**TYPE III – MODIFICATION
STAFF REPORT AND RECOMMENDATION**

Revised August 15, 2017

FILE NO.: MD 17-01, MD 17-02, MD 17-03, MD 17-04, MD 17-05, and MD 17-06:
Historic Review for the designs of six (6) cottage style homes in the Canemah
Historic District.

REQUEST: The applicant is requesting design approval for the construction of six (6) new
construction cottage style dwelling units, with preservation incentives to
adjustment the front, side, and rear setbacks, in the Canemah Historic
District.

Proposed House 1:

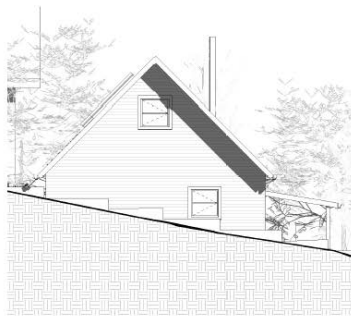
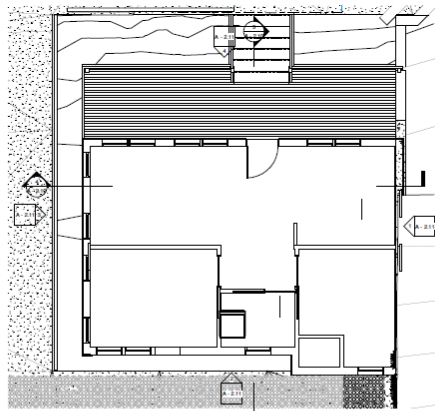
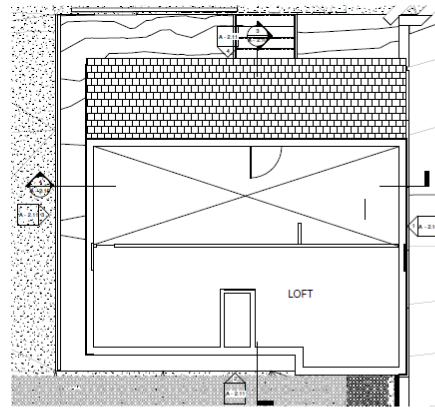
In the design of home number one, the applicant has indicated that they are planning to remove a significant portion of the abutting topography, creating a cutout for the home and a twelve (12) foot wide driveway on the existing lot. This home will also be located directly upon the east property line.

The proposed landscaping in front of the front of the home is unclear. The applicant will need to go through Geotechnical Review along with Site Plan and Design Review.

- a. Retaining and structural walls shall be minimized; to be faced or finished in stone, mortared basalt, or concrete, and not exceed 3 ½ feet, to complement the Canemah Neighborhood.
- b. Concrete foundations shall have a natural, parged or painted finish.
- c. Exposed foundations shall be site screened with vegetation if concrete or masonry exceeds 3½ feet, or if pilings or posts are 1½ feet above grade.
- d. A minimum of 5 shrubs and groundcover shall be installed along the façade of the front porch.
- e. Roofing shall use traditional materials such as wood shingles, composition, and metal shingles.
- f. Skylights shall be installed in inconspicuous roof slopes and skylights shall be mounted close to the roof plane, and not visible from the right-of-way.

Proposed House 2:

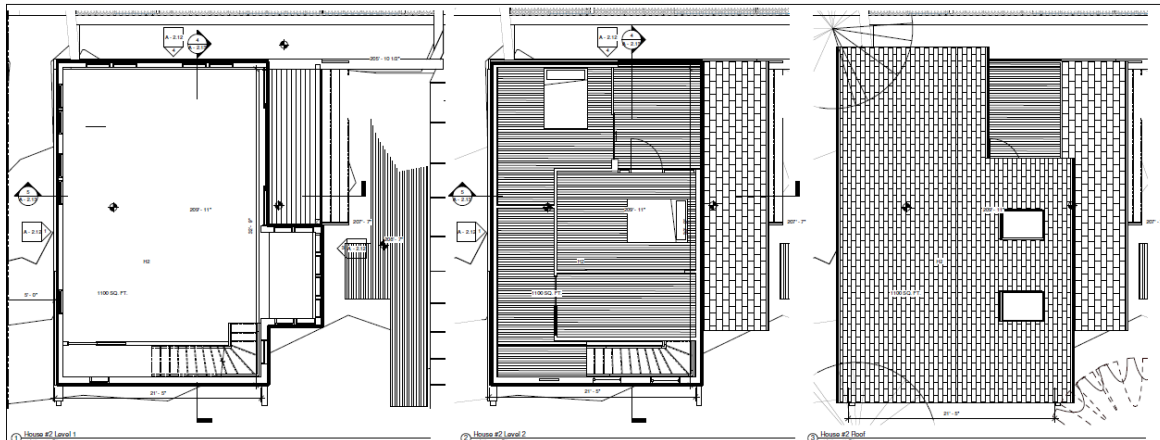
Finding: Complies with Condition. House two (2) is located approximately 40 feet south of house one (1) on the site plan, and appears to be designed as an 1100 square foot 1 ½ story modern Vernacular home completely sided in horizontal shiplap. The deck on east side of the house is with a flat, slightly elevated, with no front railing. The east side of the first story is has four large full light windows, creating a French door like entrance. To the south of the main entrance is a small bump out from the main building on which there are four small square double hung windows. To the south of the bump out is one large rectangular double hung window. The east facing deck is also covered by overhanging eave. On the second story of the east side there is a portion of the roof that has been removed to make space for a second story outdoor seating area. The entrance leading to this outdoor seating area is composed of two full light glass doors with two large square windows above the glass doors on the east side of the cutout and one full light glass door surrounded by window on south side of the cutout. The outdoor seating area is bordered on the east and west sides by a railing with thin spindles and a top rail. On north side of the first story there are four large rectangular double hung windows and one large rectangular double hung window on the second story.

The first story on the south side of the house contains one small square double hung window with a concrete planter box along the foundation of the building. The side of the east-facing bump out is visible on the south side of the house; there are two small square double hung windows visible on the side of said bump out. On the second story of the south side of the home, a series of stepped windows are used. A large double hung rectangular window is illustrated to be near the top of the structure, stepping down to two small double hung square windows.

- a. Residential doors shall complement the design and detailing of the historic style with similar appearance to wood. Doors shall be designed in a stile and rail type; panel design; with upper portion glass. The primary door may be a solid panel door.
- b. Gable roof slopes shall have equal pitch. Gable primary roofs shall have a pitch of 8:12 or greater (6:12 for Bungalow). Porch or bay roofs may have lower slope, may have hip if style allows. Roofs shall have a minimum 1 foot overhang with a maximum of 3 feet.
- c. Windows shall match the member sizing, thickness and shadowline of painted wood windows. Windows shall also consist of the following designs: double, single hung, or casement. Wood clad shall be matching in color and finish. Non-wood fiberglass and aluminum windows are acceptable if in appropriate style, and matching wood in profile, shadowline, and if similar in

- d. Concrete foundations shall have a natural, parged or painted finish.
- e. Exposed foundations shall be site screened with vegetation if concrete or masonry exceeds 3½ feet, or if pilings or posts are 1½ feet above grade.
- f. Roofing shall use traditional materials such as wood shingles, composition, and metal shingles.
- g. Skylights shall be installed in inconspicuous roof slopes and skylights shall be mounted close to the roof plane, and not visible from the right-of-way.

Proposed House 3:

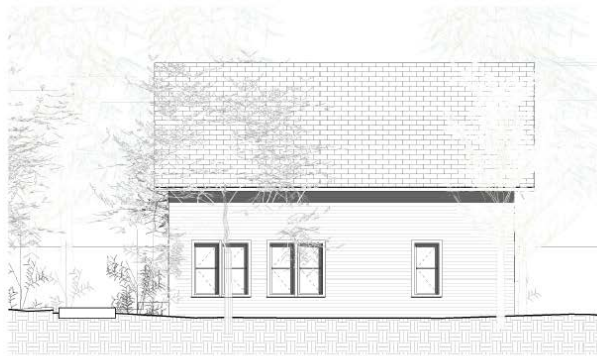
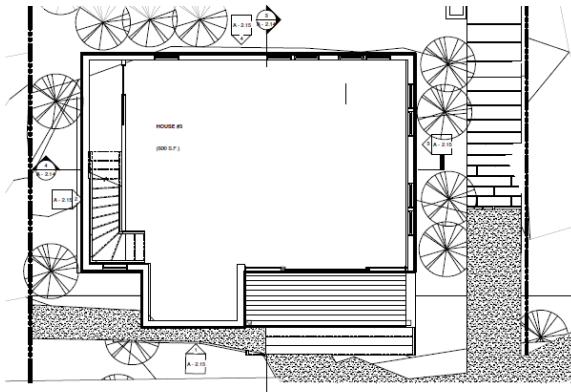
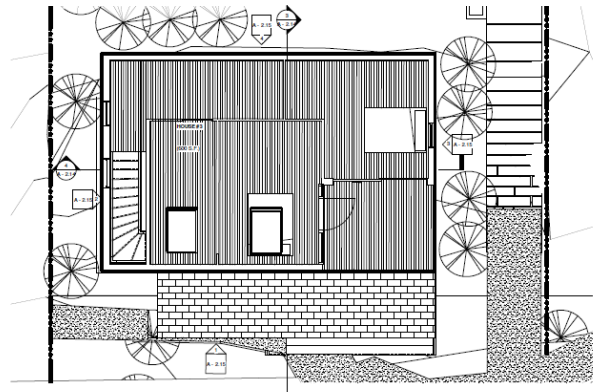
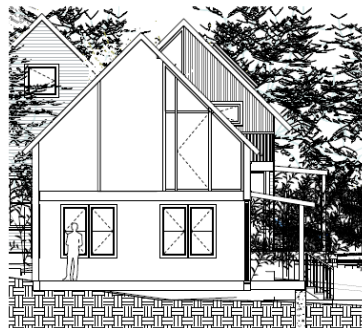
- Roofing shall use traditional materials such as wood shingles, composition, and metal shingles.
- Skylights shall be installed in inconspicuous roof slopes and skylights shall be mounted close to the roof plane, and not visible from the right-of-way.

- a. Primary residential doors shall complement the design and detailing of the historic style with similar appearance to wood. Doors shall be designed in a stile and rail type; panel design; with upper portion glass. The primary door may be a solid panel door. Sliding doors are not permitted.

- b. Gable roof slopes shall have equal pitch. Gable primary roofs shall have a pitch of 8:12 or greater (6:12 for Bungalow). Porch or bay roofs may have lower slope, may have hip if style allows. Roofs shall have a minimum 1 foot overhang with a maximum of 3 feet.

- c. Windows shall match the member sizing, thickness and shadowline of painted wood windows. Windows shall also consist of the following designs: double, single hung, or casement. Wood clad shall be matching in color and finish. Non-wood fiberglass and aluminum windows are acceptable if in appropriate style, and matching wood in profile, shadowline, and if similar in color and finish. If a non-wood style is proposed, a sample is required to be approved by the Historic Review Board.

Proposed House 4:

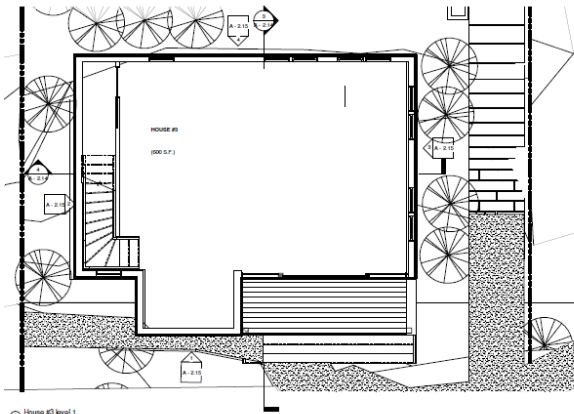
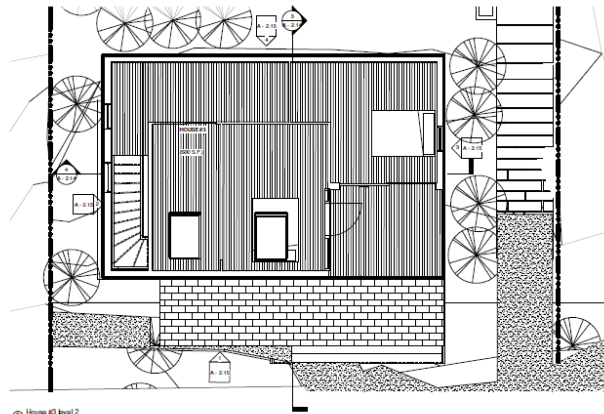
- Roofing shall use traditional materials such as wood shingles, composition, and metal shingles.
- Skylights shall be installed in inconspicuous roof slopes and skylights shall be mounted close to the roof plane, and not visible from the right-of-way.

- a. The main entrance of the house shall not be oriented towards the adjacent parking lot.
- b. Windows shall match the member sizing, thickness and shadowline of painted wood windows. Windows shall also consist of the following designs: double, single hung, or casement. Wood clad shall be matching in color and finish. Non-wood fiberglass and aluminum windows are acceptable if in appropriate style, and matching wood in profile, shadowline, and if similar in color and finish. If a non-wood style is proposed, a sample is required to be approved by the Historic Review Board.

- c. Residential doors shall complement the design and detailing of the historic style with similar appearance to wood. Doors shall be designed in a stile and rail type; panel design; with upper portion glass. The primary door may be a solid panel door. Sliding doors are not permitted on any portion of the house.

House 6:

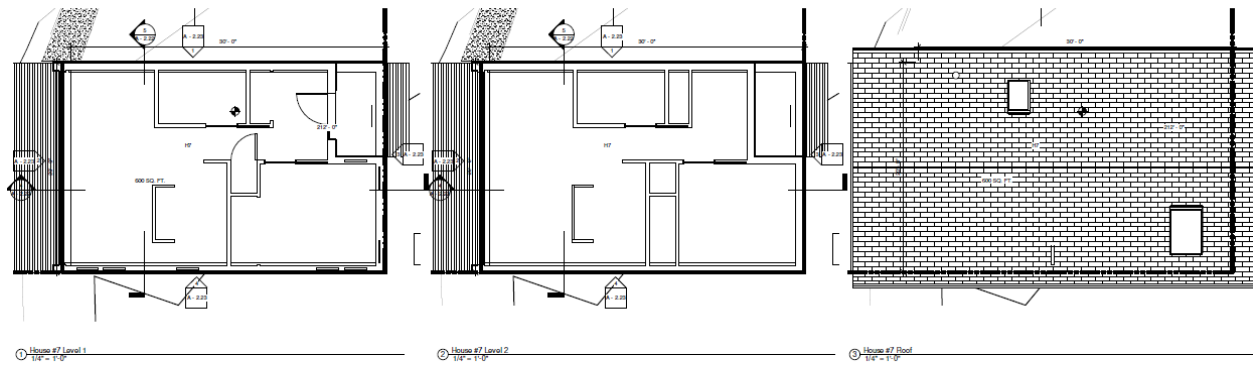
- Roofing shall use traditional materials such as wood shingles, composition, and metal shingles.
- Skylights shall be installed in inconspicuous roof slopes and skylights shall be mounted close to the roof plane, and not visible from the right-of-way.

- a. Residential doors shall complement the design and detailing of the historic style with similar appearance to wood. Doors shall be designed in a stile and rail type; panel design; with upper portion glass. The primary door may be a solid panel door. Sliding doors are not permitted on any portion of the house.

- b. Windows shall match the member sizing, thickness and shadowline of painted wood windows. Windows shall also consist of the following designs: double, single hung, or casement. Wood clad shall be matching in color and finish. Non-wood fiberglass and aluminum windows are acceptable if in appropriate style, and matching wood in profile, shadowline, and if similar in color and finish. If a non-wood style is proposed, a sample is required to be approved by the Historic Review Board.

- c. Gable roof slopes shall have equal pitch. Gable primary roofs shall have a pitch of 8:12 or greater (6:12 for Bungalow). Porch or bay roofs may have lower slope, may have hip if style allows. Roofs shall have a minimum 1 foot overhang with a maximum of 3 feet.
